UNITED STATES PATENT AND TRADEMARK OFFICE

Office Action Summary	Application No. 10/624,016	Applicant(s) TAKAGI ET AL.	
	Examiner Michael G. Bogart	Art Unit 3761

DETAILED ACTION

FIG. 1

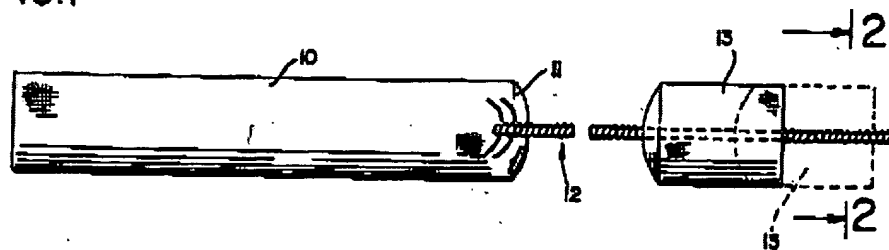
Regarding claim 1, Penska teaches a catamenial tampon comprising:

a primary absorbent member (10); and

a withdrawal cord (12, 13) having a withdrawal portion and an attachment portion, the attachment portion being joined to the primary absorbent member (10);

the withdrawal cord (12, 13) including a composite yarn (13, 14, 16) which includes a continuous string (14, 16), and a secondary absorbent member (13) joined to a part of the continuous string (14, 16) and the primary absorbent member (10);

wherein the continuous string (14, 16) and secondary absorbent member (13) are a single piece of the composite yarn.

wherein the continuous string (14, 16) which has the secondary absorbent member (13) joined thereto is in the final product identical to a string woven according to a predetermined weaving manner after being provisionally twisted, thereby forming the attachment portion and the withdrawal portion (see figure 1, below).

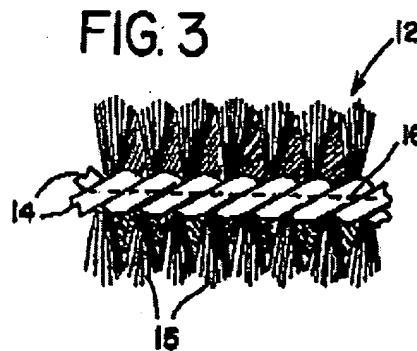
Penska teaches a string that is structurally identical to the invention as claimed whether or not the cords (14) are woven (stitched (16)) together before or after they are twisted (see figure 3, below).

Regarding claims 4 and 5, Penska teaches that the attachment portion of the withdrawal cord (12) is stitched (11, 16) to the primary absorbent member (10) such that it is structurally identical to a stitched attachment made according to a predetermined stitching;

and further wherein at least a part of the withdrawal portion of the withdrawal cord (12) is additionally stitched (11, 16) such that it is structurally identical to a stitched attachment according to the predetermined stitching manner. See *In re Thorpe*, supra.

Regarding claim 10, Penska teaches a plurality of strings (14)(see figure 3, below).

FIG. 1

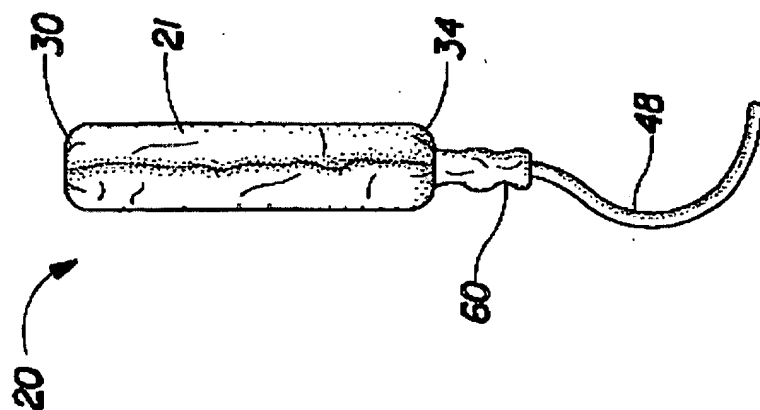
Regarding claim 1, Taylor *et al.* teach teaches a catamenial tampon (20) comprising:
a primary absorbent member (21); and
a withdrawal cord (48, 60) having a withdrawal portion (48) and an attachment portion (60), the attachment portion (60) being joined to the primary absorbent member (21);

the withdrawal cord (48, 60) including a composite yarn which includes a continuous string (48), and a secondary absorbent member (60) joined to a part of the continuous string (48) and the primary absorbent member (21);

wherein the continuous string (48) and secondary absorbent member (60) are a single piece of the composite yarn (48, 60); and

wherein the continuous string (48) which has the secondary absorbent member (60) joined thereto is in the final product identical to a string woven according to a predetermined weaving (sewing or stitched) manner after being provisionally twisted, thereby forming the attachment portion and the withdrawal portion (see figure 1, below). See *In re Thorpe*, supra.

Regarding the interpretation that Taylor *et al.* teach an end product that has an identical string and stitched attachment to that of the claimed invention, Taylor *et al.* teach that the string (48) is sewed (stitched) to the main body (21)(col. 7, line 48). If the presumably non-twisted withdrawal string of the reference were sewed to the main body while the string was in a gently twisted state, it would untwist itself after attachment to the body as it returned to its naturally untwisted state, making the end product identical to the claimed invention.

Regarding claim 3, Taylor *et al.* teach a diameter ration of the attachment portion (60) to the withdrawal portion (48) of the withdrawal cord (48, 60) is at least about 1.5 (figure 1).
